Access Compliance Report

Public Rights-of-Way (Curb Ramps)

Intersection ID: N/A	Main Street: BEREWICK_TOWN_CENTRE	Cross Street: N/A	Location: SE
ADA ID: E19B63AC93AB	Ramp Type: BlendTrans1	Initial Pass/Fail: Pass	Overall Compliance: No
Severity Score: 0			
Codes/Mitigation Info/Possible Solution		Field Measurements/Component Compliance

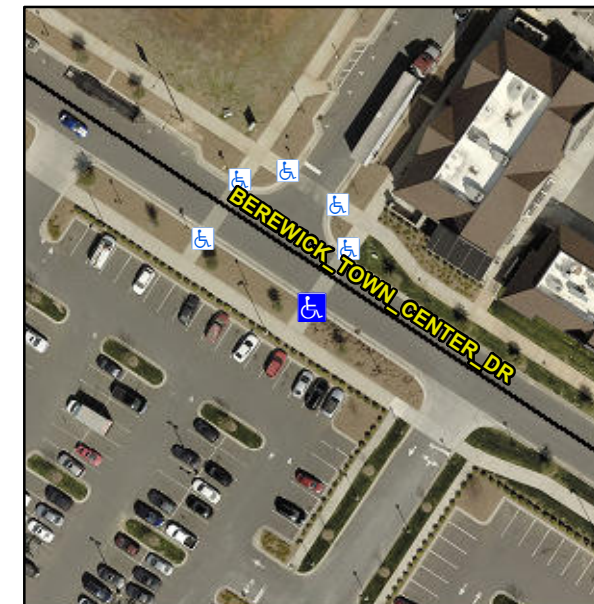
XWALK PAVERS

Not Found, R305.2

Remove & Replace Curb Ramp With Two New Directional Ramps or Equivalent.
